**STATE OF TENNESSEE  
DEPARTMENT OF TRANSPORTATION**

**Re:           ADDENDUM #6**  
**Contract No. DB1601**  
**County:     Maury**

This addendum revises the procurement schedule/submittal deadlines and revises the RFP Books  
Also, this addendum revises Project No. 3

**State Route 396, Saturn Parkway Extension,  
Maury County- TENNESSEE**

OFFICE OF TRANSPORTATION  
 DEPARTMENT OF TRANSPORTATION  
 FIGURE 3  
 SATURN  
 PARKWAY  
 EXTENSION

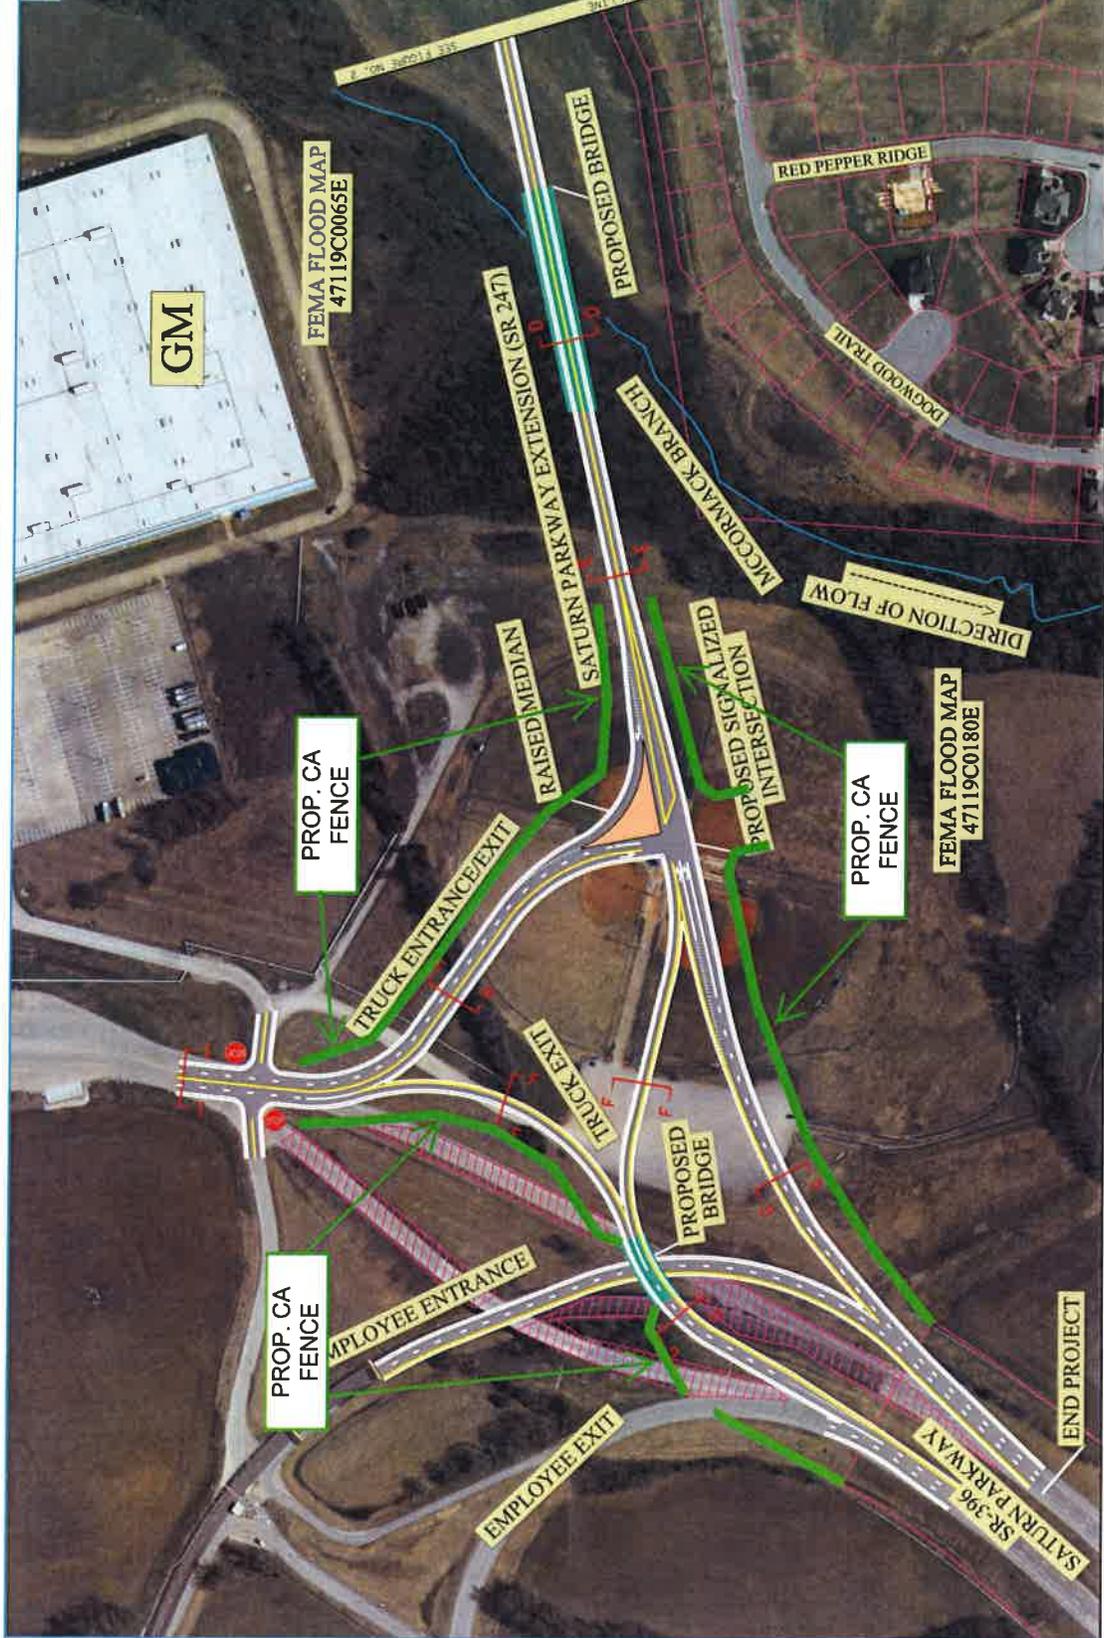
"The Design Builder shall install Controlled Access fencing from where it currently ends on SR-396  
(Saturn Parkway) to beyond the GM Entrance / Exit Intersection as depicted in the attached exhibit.  
Attached is an exhibit that depicts the limits of CA Fence. The CA fence shall be 6' chain link fence as  
specified in Std. Dwg. S-F-10B."

PROP. CA  
 FENCE
